Access Compliance Report

Public Rights-of-Way

| Intersection ID: 14049 | Main Street: CLEMENT_AV | Cross Street: PARK_DR | Location: | N |
| ADA ID: 30C868844C61 | Ramp Type: PerpDiag | Initial Pass/Fail: Fail | Overall Compliance: No | Severity Score: 22.5 |

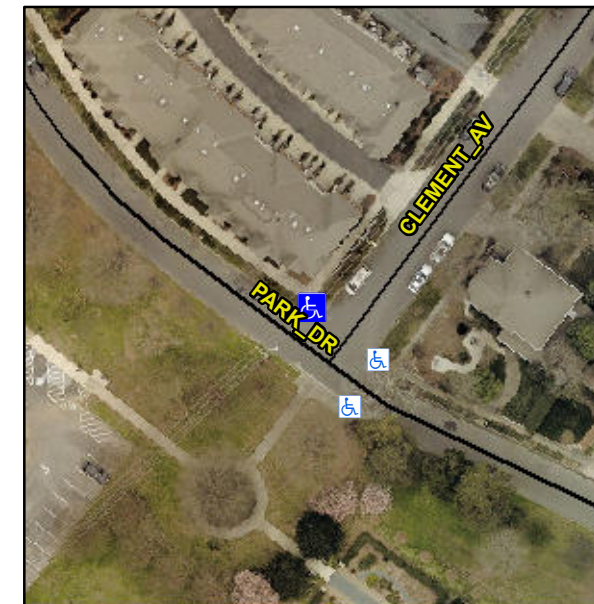
Not Found, R304.5.1, R304.2.2, R304.5.3

| Compliance | Description | Data | Compliance | Description | Data |
|------------|-----------------------|-------|------------|-----------------------------|-------|
| N/A | Ramp Length (in) | 53.0 | No | Ramp Slope (%) | 8.7 |
| No | Ramp Width (in) | 43.0 | No | Ramp XSlope (%) | 3.4 |

Remove & Replace Curb Ramp With Two New Directional Ramps or Equivalent.
